## Replies to referee 1

The authors present a comparison between local (LPC) and global (GPC) current-free boundary conditions applied to an axisymmetric, hybrid simulation of a Hall effect thruster. They apply these boundary conditions to three separate system configurations: one with an external cathode (EC) inside the magnetic field separatrix (MS), one an EC outside the MS, and one with an internally mounted cathode, using four separate domain sizes, i.e., 12 different cases. There are several issues noted for this manuscript to be considered for PSST in its current form:

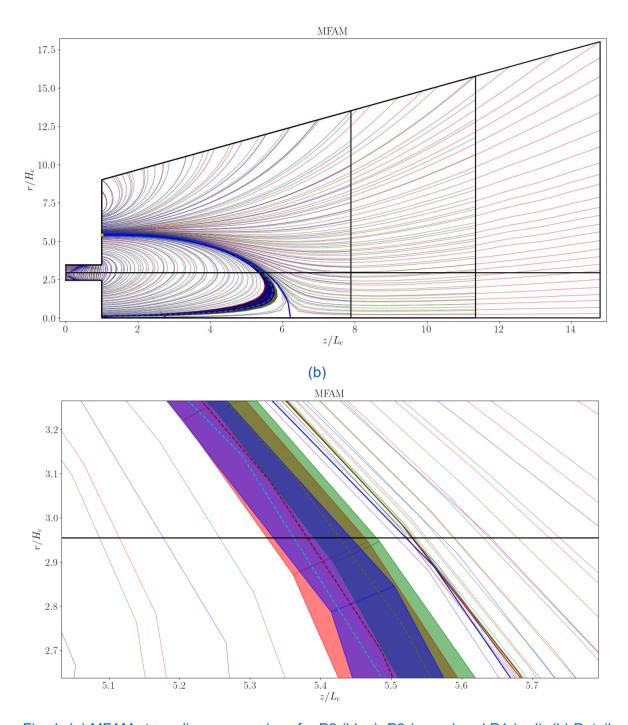
- 9) Table II is interesting (especially,  $\phi_-^\infty$ ) but more details are needed. (i) Why do we not see the convergence of results? For instance, LP2C1 = 13.22 V; LP3C2 = 14.15 V; LP4C1 = 10.97 V. (ii) The small thrust with smaller domain is attributed to magnetic force. (iii) Please provide more clarification and physics discussions. The authors mention that the results are "converging", but the main interesting physics is what is the correct value of  $\phi_-^\infty$ ? For instance, if the cathode potential is 0 V, the far-field potential should be Vcc, which is a positive value with respect to the cathode potential? (v) Finally, while it is appreciated that the authors provide all values thoroughly, many of the values seem to be less interesting. For instance, all discharge power, current, efficiencies are not that sensitive to the far-field boundaries.

- (i) We thank the reviewer for pointing out this important aspect, which highlights a difficulty associated with the use of a Magnetic Field Aligned Mesh (MFAM) for solving the electron fluid equations. We have clarified this point in Section III of the revised version of the manuscript, as detailed below.

The variations in the coupling voltage  $V_{cc}$  reported in Table II for C1 cases are not due to fundamental changes in the plasma solution with plume size, but rather stem from numerical differences in the construction of the MFAM. The MFAM is generated from the applied magnetic field. The cells of the mesh are defined by the intersection of the magnetic field streamlines and equipotential lines, which are obtained through the integration of the magnetic field. For each plume size, the MFAM is built to balance accuracy and computational cost, ensuring a controlled cell skewness and resolution. Since the applied magnetic field is highly non-uniform in the near-plume region, the resulting distribution of magnetic field lines is also highly non-uniform (refer to Fig. 1(a) below). Thus, the optimal selection of magnetic isolines that define the MFAM cells becomes a nontrivial task, which typically results in variations in the cell layout across different plume sizes. Consequently, the cathode magnetic line (CML), defined within each MFAM by the field line passing through the cathode injection center, may differ slightly between plume sizes. This leads to small differences in the intersection point between the CML and the thruster channel midline used to estimate  $V_{cc}$ , as illustrated in Fig.

1(b). These geometric differences explain the variations in  $V_{cc}$  among the C1 cases (maximum of about 1% of  $V_d$  for plume sizes P2-P4), and do not reflect significant physical changes in the cathode-beam coupling process. In fact, compared to C1 cases, variations in  $V_{cc}$  among C3 cases reported in Tab. IV are lower (maximum of about 0.3% of  $V_d$ ). This is because the CML is the symmetry axis for C3 cases (cathode at the axis), and the magnetic line that connects it to the thruster channel midline is the magnetic separatrix (MS), which is the same for every MFAM regardless of the plume size (refer to Fig. 1). For C1 cases, mesh-related variations in  $V_{cc}$  have been quantified and explicitly stated in the manuscript.

On the other hand, mesh-related variations in  $\phi_{\infty}$  are lower, since this quantity is related to far field plume dynamics, and they have also been quantified and explicitly stated in the manuscript. Furthermore, it has been verified that these variations do not affect the qualitative trend found for  $\phi_{\infty}$  with the plume size.

Finally, the calculation of  $V_{cc}$  has been improved for C1 cases through a finer interpolation of the electric potential solution to the crossing point between the CML and the thruster channel midline.
